Calculation Number: NAI-1149-026

Title: Palisades Design Basis Cask Drop Accident AST Radiological Analysis

Attachment 1 Verification Comments for Calculation NAI-1149-026 Rev. 0**Comment 1**

Figure 1 CDA RADTRAD-NAI Model

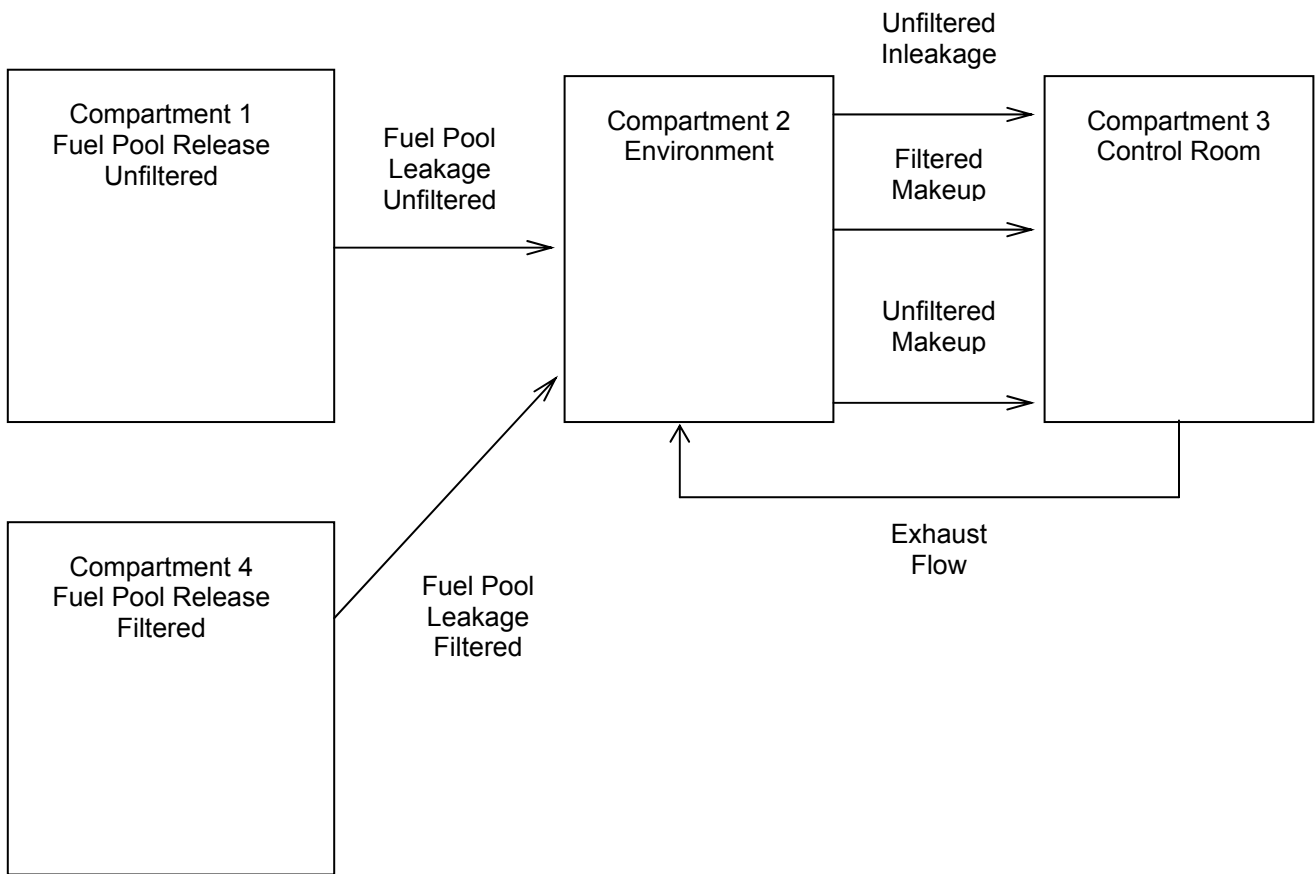
Table 7-1 – The release fraction timing file includes two 0.1E-2 hour delays before the release begins. This 0.002 hour (7.2 seconds) delay should not have a significant impact on the total dose.

Response: Agreed. Minimal time periods are required in the release fraction timing file so that the main release will occur during the third release phase. This is required because the overlying pool model only operates during the third release phase.
